BEKER INDUSTRIES CORP.

Purchase Order No. **COF 20841**Date: **July 22, 1975**Requisition No. **635**Cost Code No. **168-401A**

Subject: Conditioning of reservoir for liner installation.

Subject: #3 GYPSUM TAILINGS POND DIKE FAILURE

(How Situation Appeared at 8:00 A.M. Tues. March 2, 1976)
Per. description & sketch by C. WHITING, Proj. Engr.
SIDE VIEW or cross section looking east.

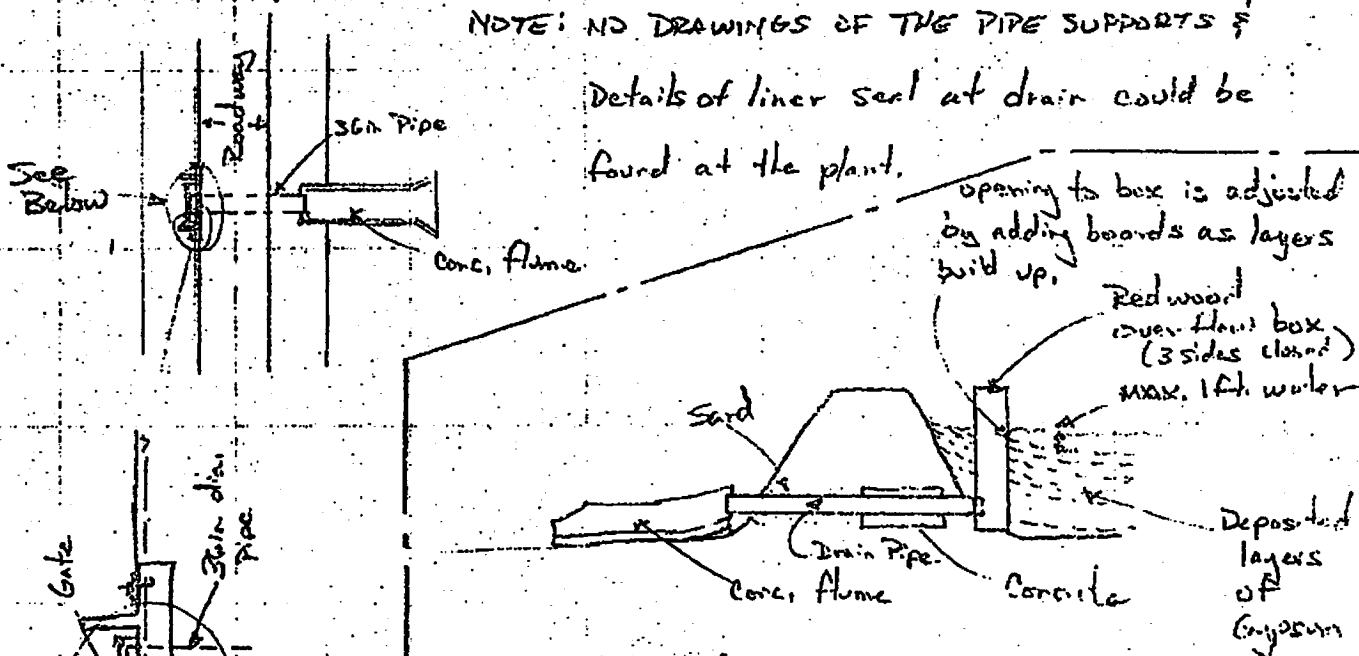
1. The new overflow system should be designed to minimize the chances of leakage around the area of the new drain pipe.
2. The repair work on Gypsum Pond No. 3 (south) should be expedited as much as practical so business interruption will be minimized should Gypsum Pond No. 2 develop a leak.

NOTE: NO DRAWINGS OF THE PIPE SUPPORTS & Details of liner seal at drain could be found at the plant.
